Internal Ref: EXTERNAL/2025/0015

8 September 2025

Inner West Council Response: SSD-82714716 – WestConnex Dive Site Build-to-Rent (Annandale)

Figure 2: Apartment 1.08 windows near plant room. Repeats on all levels

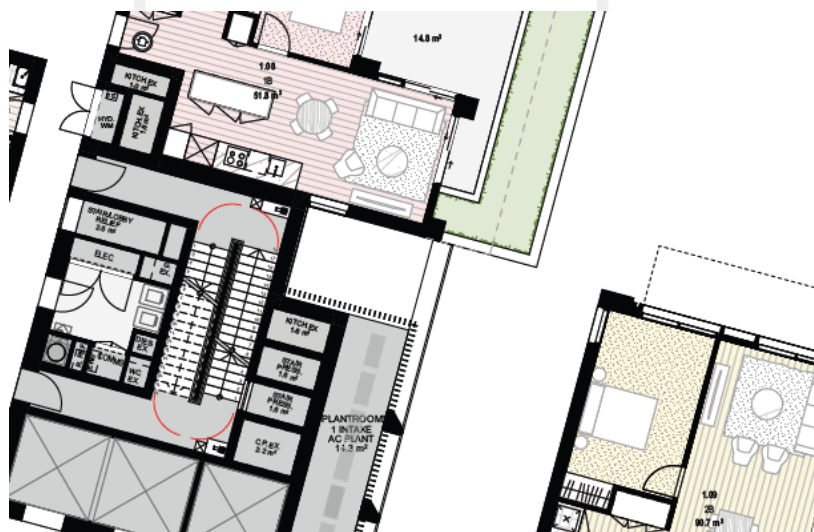
The proposal includes a repeating living room window (apartment 8 (all levels)) adjacent to areas labelled 'PLANT ROOMS 1 INTAKE AC PLANT'. The interface of these apartments to the plant rooms needs to be further refined to ensure adequate acoustic privacy is provided whilst maintaining good internal amenity. In this regard, a fixed window with the suitable acoustic treatment could be annotated on the plans.
